**RE: 105 Bartlett St**

**TAC : February 2, 2021**

Dear Members of TAC: Here is my list regarding 105 Bartlett Street. Thank you for taking the time to review it.

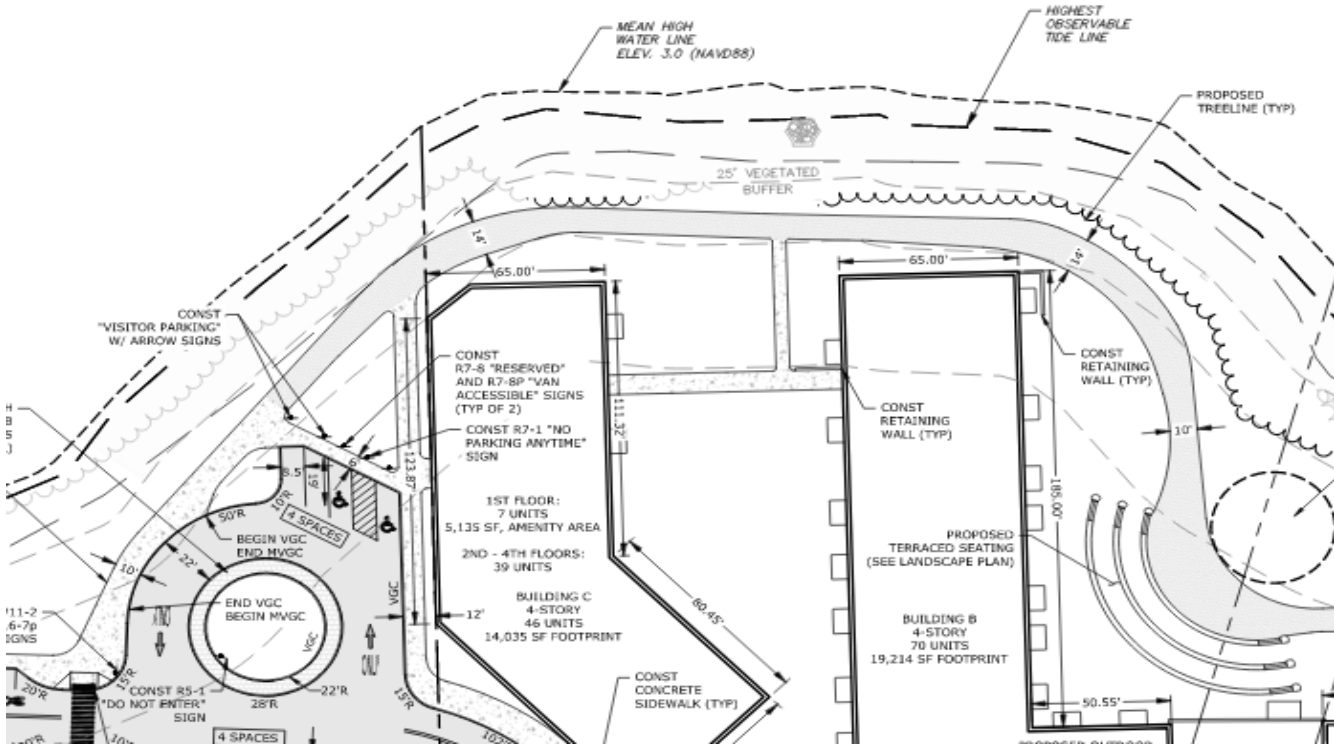
1. The actual **width** of Building A and the lower part of Building B are STILL not marked (pg 13).
2. Large amounts of structures are **still in the 100' buffer**. A lot with 4000 sf (40 X100) of wetlands adding one 160sf shed= 4% in the 100' buffer. Lot 157-1 with around 58,000 sf (580X 100) of wetlands, 15,027sf of wetlands intrusion = 25% of the wetland buffer covered. Building B is still about 10' from the 50' buffer. The latest design of Building C returned it directly onto the 50' Buffer near the corner (circle side). It had been moved for **safety** previously.

3. The **Fire Road** is now about 1.5 times wider than it was, ALL of it should be moved out of the 50' to 100' buffer. There still is no Fire Truck Exit for the Fire Road near building C or ANYWHERE!

4. **Truck entrance** into the property from Islington/Cate St seems like it will require a pretty wide turn. Should the planter next to Ricci Windows Store be reduced slightly to widen that corner? (pg 133)

5. TAC #12(pg 39) states to remove trees from the **Dover St View Corridor**. Adding trees which grow to be 10'-15' high instead will have the same affect (L2-pg 35). This area does not seem like it will be able to be viewed from McDonough St (proposed grade 17.5 was 5?). No trees should be allowed because it is likely obstructed by its grade (pg 132). Native low growing wildflowers would be nice there.

6. Proposed parking Lot **Grade** as well as preconstruction grade(s) are not shown(pg 132).
7. **Parking supply** still shows 20 spaces from the Private Road (pg 11), although on TAC list #1 (pg 39) states they were added next to building A. Underground Parking was 119 in December to 95 spaces in January. One less at circle and the parking lot showed 103 and now 95. *Counts just don't seem to add up without the mystery 20 spaces.*

8. **Correction should be made for future waterfront developments.** *NHDES uses the HOTL for tidal waters, not the mean high water line to define waterfront property. The measurements should be corrected to depict this.* In this case it's about 9540sf of extra square footage which is being counted as Community Space. They meet the 20% target but others may not. The lot size was 4.71 acres in December, now shown as 4.72 acres; lot line is in the same place.

9. #41 of TAC list (pg 40), was unable to find the **dumpsters** on C102-2.

10. I'm assuming all **storm drain covers** on this property will be high volume. Are they bicycle, baby carriage and pedestrian friendly where needed?

11. Not sure if ALL **storm water culverts** have *one way valves* to prevent excessive erosion of the Pond during high volume events!
12. **Snow storage** area between the circle and the garage shows large trees proposed. A Giant Green Arborvitae tree (pg 34,35) will be between 12 to 20' wide and about 50' tall. The American Elm would need to be positioned carefully. These proposed trees *will limit snow plow and bucket loader access and movements*. The ramp is a great idea. Will it interfere with the flow to PC87?  
The **Snow storage** at the end of the parking lot near Building A should *be reconsidered*. There is a proposed easement to Lot 164-4-2, as well as for the city. *Snow storage seems unrealistic in this location.*

13. **Greenway storm water management** is hard to understand. It is proposed as a 14' to 20' wide paved area with porous pavement, almost as wide as some side streets. I notice ONE storm drain added near the Rain Garden (pg 23). It seems more storm water management is needed to keep the trail's storm water from flowing directly into the North Mill Pond during high rain events or when deep snow melts, especially near buildings C and B. **THIS WIDTH SHOULD NOT BE ALLOWED IN THE 50' BUFFER**, even if it is porous. **ALL** of the Fire Road should minimally be in the 50 to 100' buffer with grading and proper storm water management as any other road would require.

14. Years ago lights were not half as bright and street lights were spread about 50 to 75 feet apart. One LED is excessively bright therefore a lot less is needed. Studies have shown lighting gives a feeling of security but does NOT reduce crime. Having a little less lighting encourages people to be more aware of their surroundings and less likely to venture out of their comfort zone. The **lighting** still seems excessive (pg 19), proposed changes seem minimal. I was unable to find a current lighting plan for the road. Has that been changed? I was unable to find the queues listed on the plan on the Pemco Website. **The lighting legend should be clearer**, the circled dots and numbers of lights do not seem to match what is on the plan. Motion detective lights can be energy saving and better for lower use areas and after certain times of day. *Without proper information and the grade of the parking lot, the style of lights (heights, brightness, direction) it's hard to determine how much light will be shining in first and second floor windows on McDonough St and other impact zones.*
